Modification Recommended Service Note

M9157C PXI Hybrid Single SP6T Switch, DC to 26.5 GHz, Terminated

Serial Numbers: TH60450001 – TH61350204

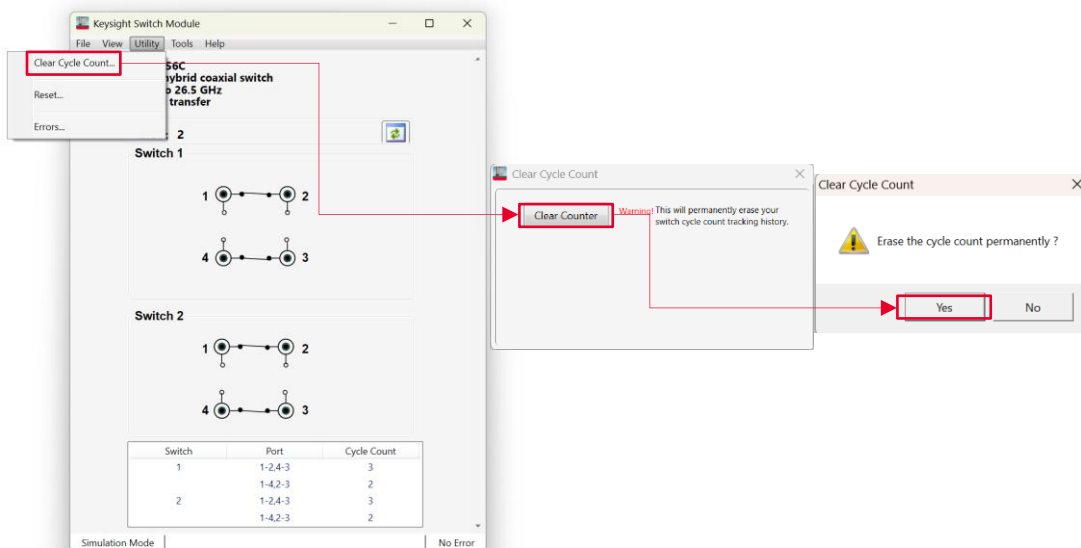
The cycle count of the unit is abnormally high. Fresh units from the factory have a cycle count of 16777215 cycles. This number is the default value for the EEPROM that stores the cycle count information. Due to a factory process issue, the cycle count was not reset. When users start using the switch, the cycle count starts from 16777215 onwards.

Clear the Cycle count using the Soft Front Panel (Keysight Switch Module)
Utility -> Clear Cycle Count -> Clear Counter -> Yes
